Maxtor Corporation  
500 McCarthy Boulevard  
Milpitas, CA 95035 USA

To: T10 SAS Protocol Working Group  
Contact: Mark Evans  
Phone: 408-894-5310  
Email: mark\_evans@maxtor.com  
Date: 27 April 2004

Subject: SAS-1.1, ST\_T (transport layer for SSP target ports) state machines

Figure 116 — ST\_T (transport layer for SSP target ports) state machines

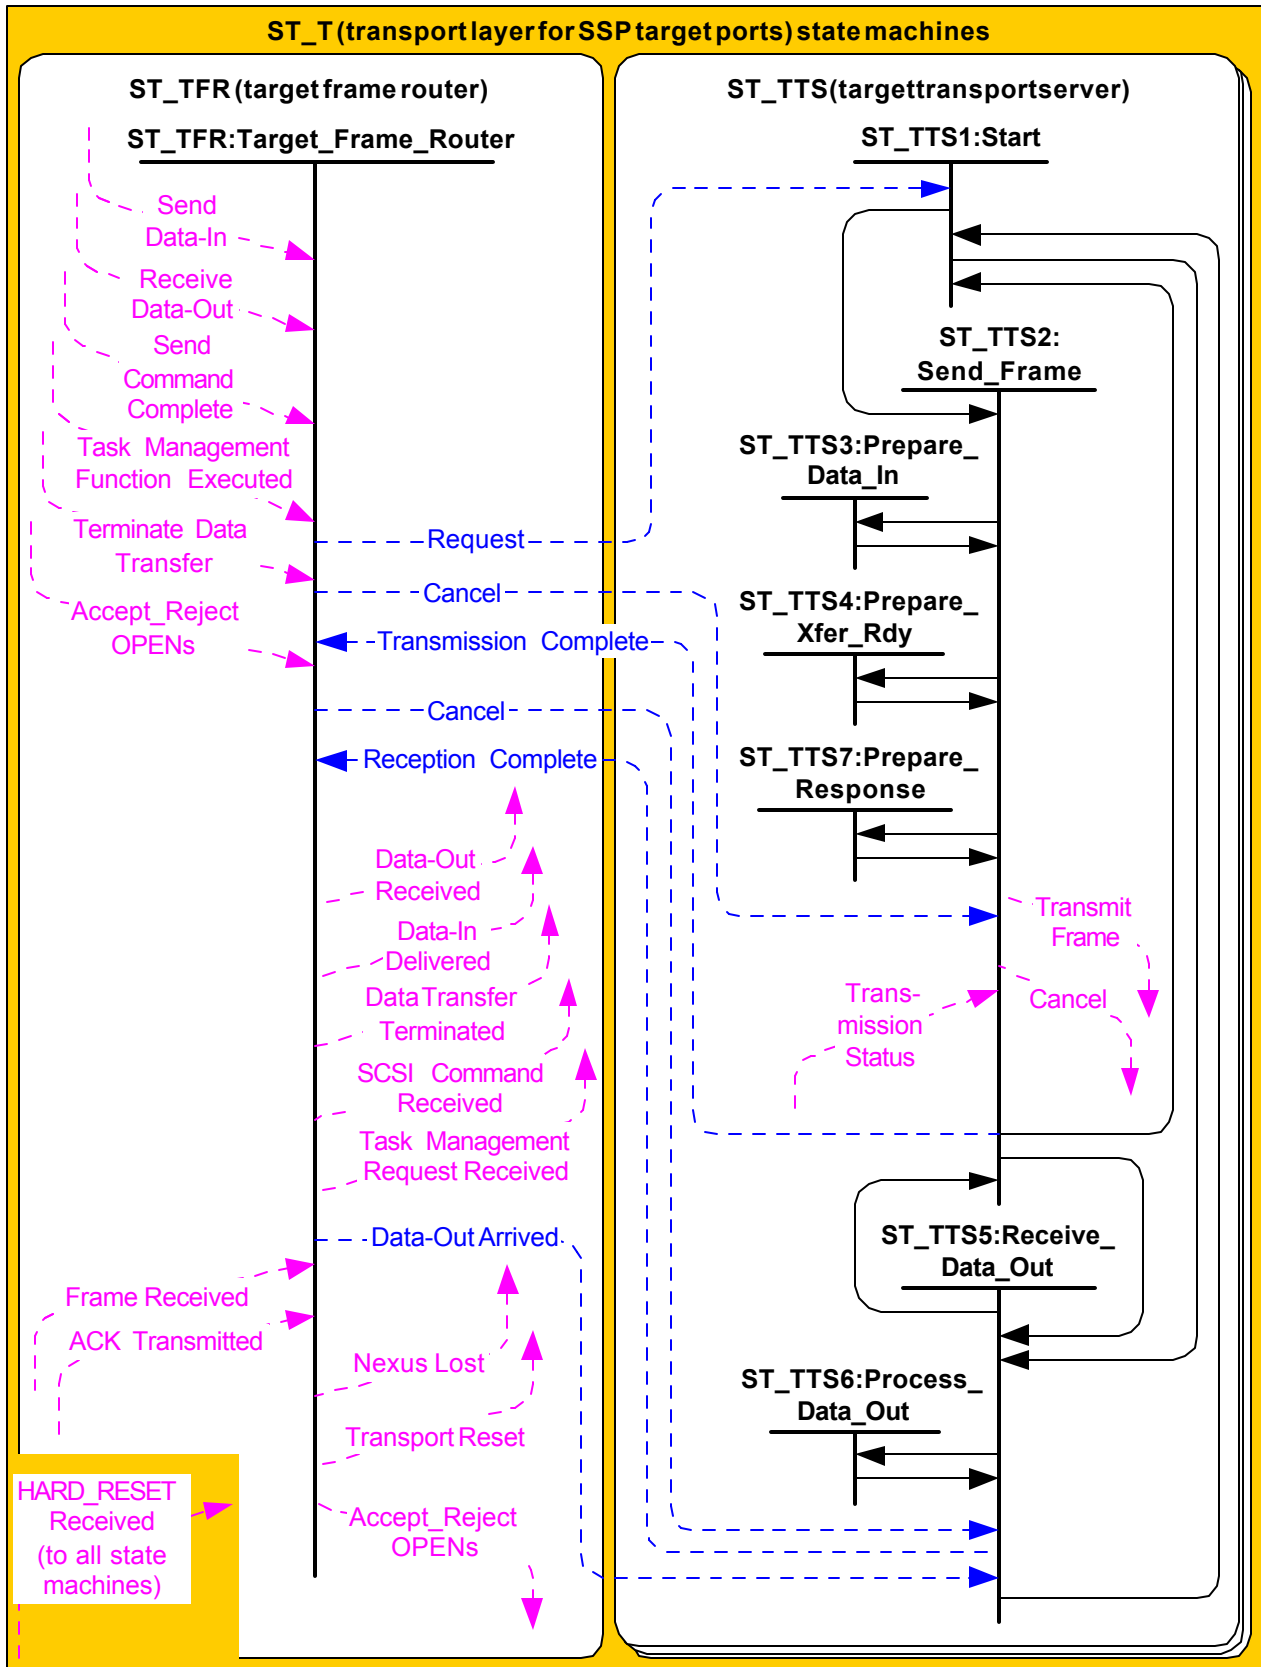
This proposal evolved from adding transport layer retries and the new protocol service, Terminate Data Transfer, to the SSP transport layer state machines. While including these elements, changes were made to simplify and clarify the description of these state machines. These changes include having all communication with the target's SCSI application layer be processed by the target frame router state machine, having a virtual target transport server state machine for each tag, and having the target transport server state machines be persistent between power cycles.

Having all communication with the SCSI application layer be processed by the target frame router state machine provides the ability for that state machine to maintain context for all tasks in process so that it can abort tasks as necessary. Having target transport servers for each tag provides the ability for one state machine to maintain context to process all elements of a task (e.g., XFER\_RDY transmission, data transfer, and response). Having the target transport server state machines be persistent between power cycles simplified their description.

Figure 116 shows the ST\_T state machines.
